भारतीय राष्ट्रीय राजमार्ग प्राधिकरण National Highways Authority of India

NHAI/PIU-RMNG/14014/2022-23/

Date: 07.10.2022

Sub: Consultancy Services for Preparation of Detailed Project Report for the Rehabilitation and Upgradation of Tamil Nadu / Karnataka Border - Bangalore section of NH-209 in the State of Karnataka (DPR/Kar/Phase-IVB/2/2010) - BRT Stretch from Design chainage from 266+449 to Km 288+936 (22.487 Kms) - Compliance to EDS reg.

Figure 8.3. Diagrammatic representation of isolated and wall type piers. Source: Adapted from Singh et al. 2010. Illustration by Niharika Saxena

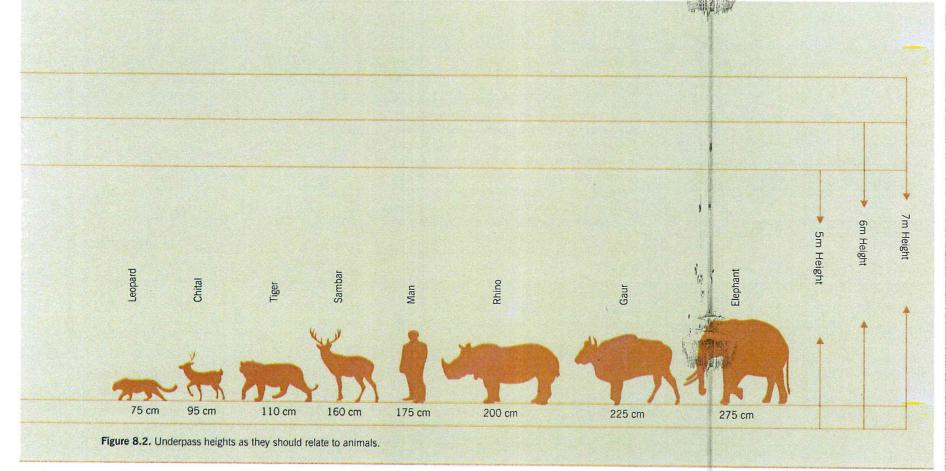
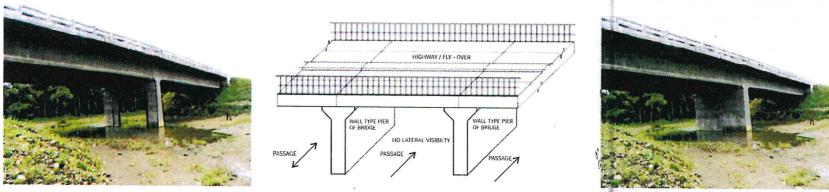
6	Please submit the No. of RCC Culverts, dimension of it for forest area.	Details were attached in Annexure - 3 Proposed List of Bridges and Culverts.
7	The recommended option shows higher speed of 43-100km per hr. This will lead to increased human-wildlife conflict, Mitigation measures may be submitted with regard to it.	Speed brakers shall be provided as per IRC guidelines and Warning Signboards related to Wildlife shall be installed for road users. Please refer Annexure-4 Mitigation Measures as per Wild Life Authorities.
8	In case of approval of recommended option, what would be the <u>Status of existing road</u> . Since, simultaneous working of both the road will sandwich the portion of Sathyamangalam Tiger reserve and Biligiri Ranganathaswamy tiger reserve and will isolate the particular forest patch. This may act detrimental to Wildlife.	This is to inform that No Traffic Movement shall be allowed and not utilizing the existing BRT Road Stretch from Km 273.156 to Km 290.706. The Proposed new alignment will also avoid human animal conflict and an undertaking form NHAI is attached as Annexure - 5. Undertaking Letter from PD, PIU, NHAI, Ramanagara regarding existing BRT stretch not utilizing for Traffic Movement.

The design of the walls and the piers of an underpass can significantly improve the acceptability of passage structure by animals. Isolated piers are more favourable than wall-type piers: wall-type piers reduce lateral visibility and increase tunnel effects, especially for species that move in groups, such as chital. The inclusion of a cross beam at the top of isolated piers further improves their acceptability. Figure 8.3 shows line drawings and constructed animal underpasses with wall type and isolated piers.
